Re: Hillsborough County - AP
Permit Amendment
Three Trucks and One Railcar
Loading Stations

Re: Central Florida Pipeline Corporation
Modification to Existing Air Pollution Source
TN6 and C4 Flare (AC48-188406)

Central Florida Pipeline Corporation (CFPL), a subsidiary of GATX Terminals Corporation (GATX), is in receipt of your request for additional information relative to the permit to modify an existing air pollution source with the proposed installation of a Flare Unit at the Taft facility, Orange County, Florida. In response to the Department's questions, GATX provides the following information:

TURBINE METER BY-PASS SYSTEM
FOR FLARE TESTING

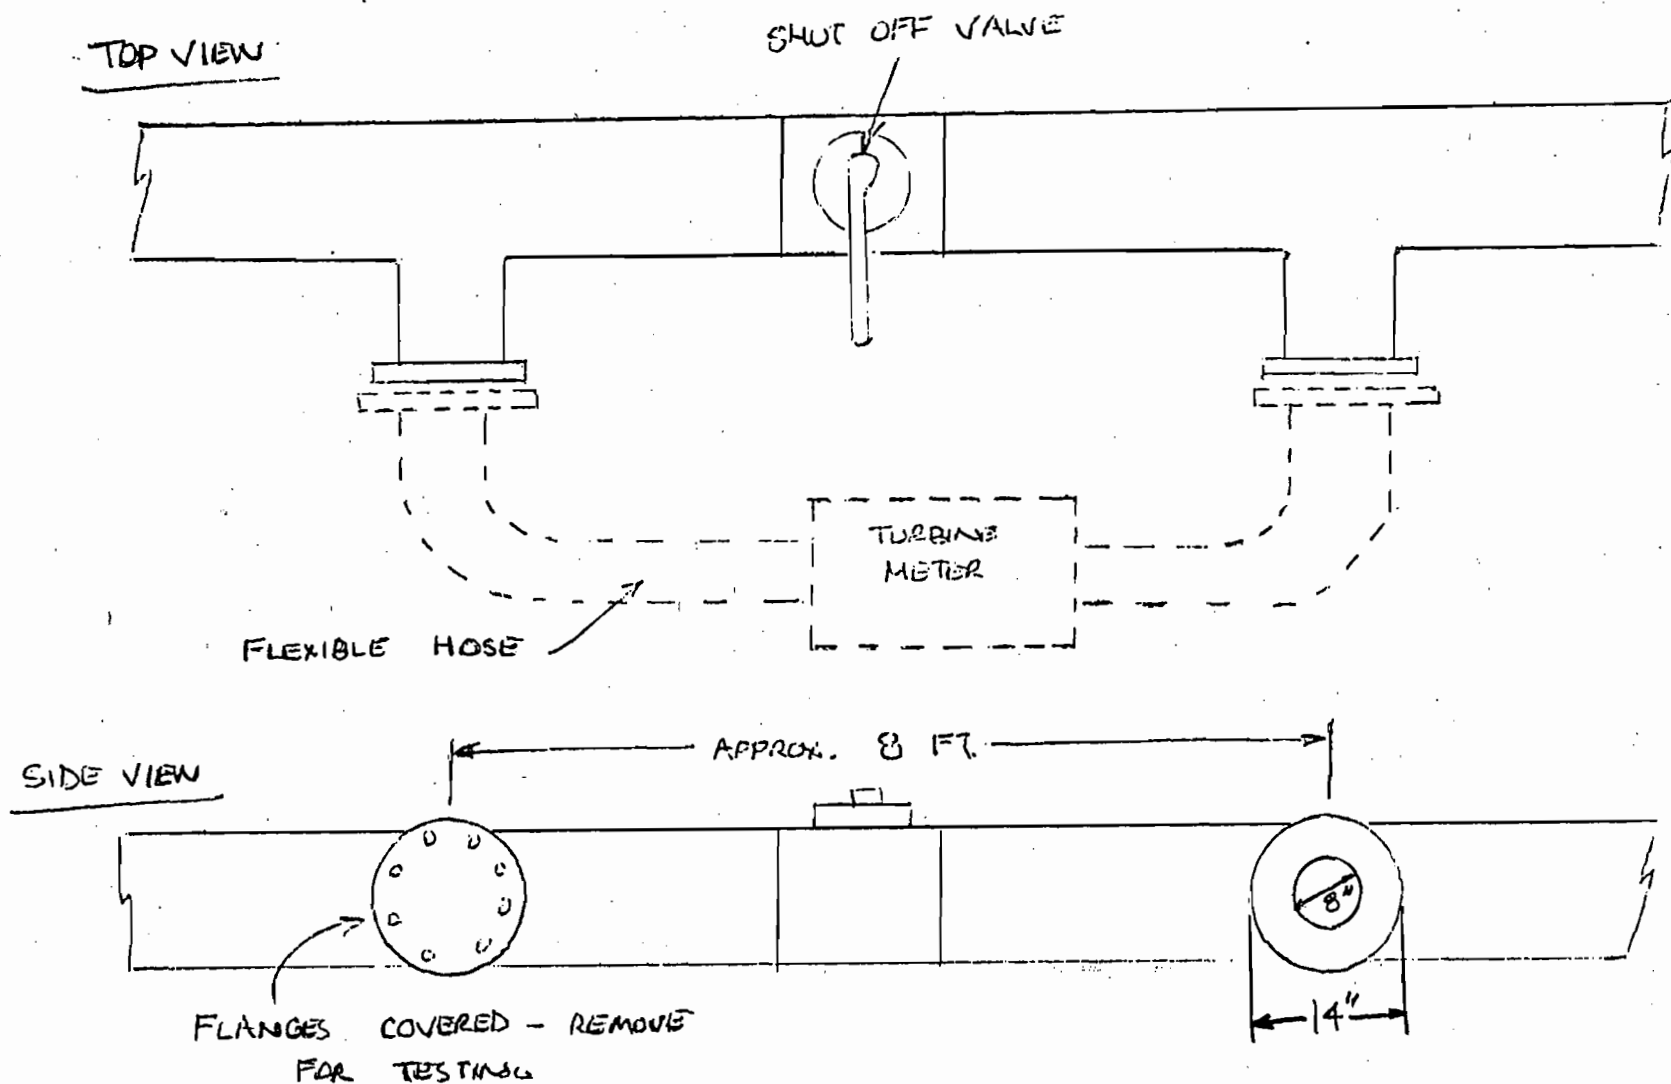
8. To meet the 35 mg/l VOC emission standard, the flare should be enclosed so that appropriate compliance testing can be conducted. Please submit a stack drawing showing sampling locations.

Response: EPA has established an alternative performance standard for flares to ensure compliance with the 35 mg/l standard. The flare testing procedure is contained in 40 CFR 60.18 (copy attached). This alternative method was developed to avoid having to stack test flares using conventional stack testing techniques. Under this method all measurement/samples are taken upstream of the burner prior to combustion. Therefore, enclosure of the flame is not

necessary. See Attachment IV for an example of the proposed alternative method.
